Product Change Notification

Date Issued :	September 23, 2024	PCN Number :	515953
Reason for Change :	Capacity change or tool replacement		
Description of Change :	This PCN is to inform you that Molex Lincoln Nebraska is adding replacement tooling impacting the parts in the attached list. There will be no impact to the Form, Fit, Function or Appearance of the Housings produced from this tooling when compared to the current tooling. There will also be no impact to the Finished Goods Form, Fit, Function or Appearance that uses the produced Housings.		
Assessment of Change :	First Article Inspection SPC / Capability Studies		
Planned Implementation Date :	May 16, 2025		
Customer Sample Availability Date:	February 07, 2025		
Last date to request Samples by Customer :	December 02, 2024		
Please note if Samples are not requested as per Customer Samples Request date, it may take additional 4-6 weeks to arrange Samples.			
Traceability Code Markings / Date :	Product made after planned implementation date can contain the change

MINI-FIT 2ckt Housing - Right Angle Header Housing

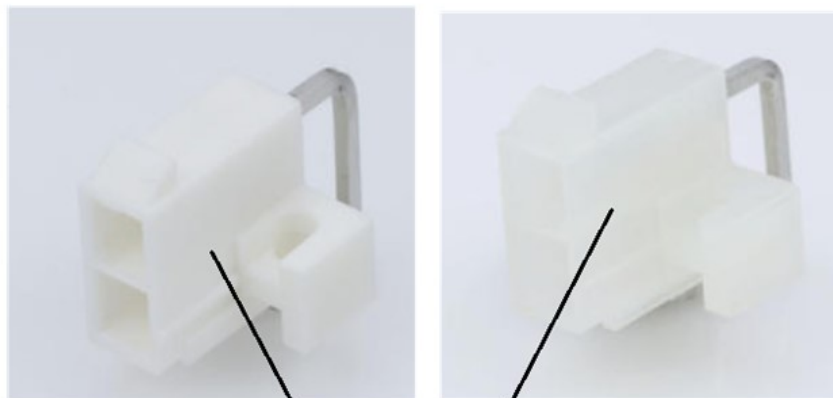
New Tooling Only produces Housing Component

- To ensure continuous product quality and delivery, Molex Lincoln, Nebraska is adding replacement tooling to support the 2ckt Mini-Fit Right Angle Header Housing.
 - New Tooling will be an exact replica of existing
- There is NO impact to Form, Fit, Function or Appearance of the Housing
 - Finished Goods also have NO impact to Form, Fit, Function or Appearance
- Part Numbers Impacted
 - See attached list
- Samples and Qualification Reports
 - Samples available upon request after date shown above
 - Qualification Reports available upon request after February 7, 2025
 - Qualification Reports need requested by December 2, 2024
 - Please note if Qualification Reports are not requested by the December 2, 2024 date, it may take additional 4-6 weeks to arrange for Qualification data to be available.
- Questions/concerns contact your Molex Account Manager
